STAFF REPORT: 03-11-20 MEETING

APPLICATION NUMBER: 20-6659

ADDRESS: 14830 GLASTONBURY

SCOPE: REPLACE TWO FRONT ELEVATION WOOD WINDOWS WITH VINYL WINDOWS,
REPLACE ONE REAR ELEVATION WOOD WINDOW WITH A VINYL WINDOW

HDAB Designation Photo - 2006

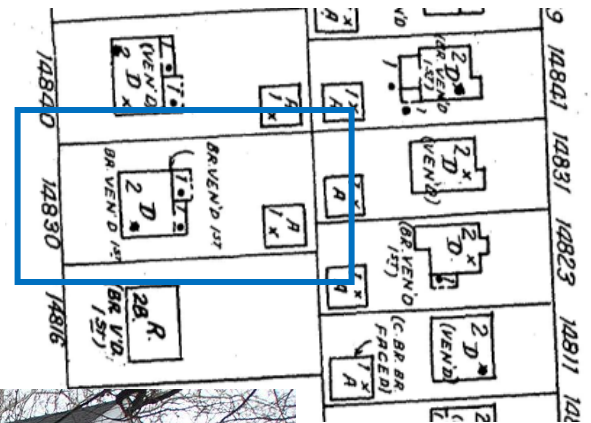
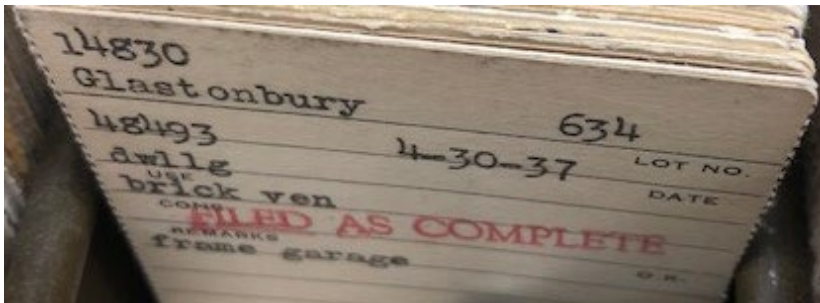
- The applicant showed the existing wood windows need repair, however it was not demonstrated the windows are economically or technically beyond repair.
- There are nineteen windows on the house; 75% of which have been replaced.
- The front elevation was designed to a higher architectural standard than the sides and rear, as evidenced by the second floor overhang with decorative finials/hip-knobs, large first floor window openings, detailed door surround, and stone veneer.
- Staff views the two windows as a design unit, balancing out the front entry. Therefore, the dimensional quality of the existing windows are historic and architectural character-defining features of the house.

It is staff's opinion that the work as proposed will result in the removal of historic materials and the alteration of features and spaces that characterize the property. The work is also not compatible with the property's historic character. Staff therefore recommends that the Commission deny a Certificate of Appropriateness for the work as proposed because it does not meet the Secretary of the Interior Standards for Rehabilitation, Standards:
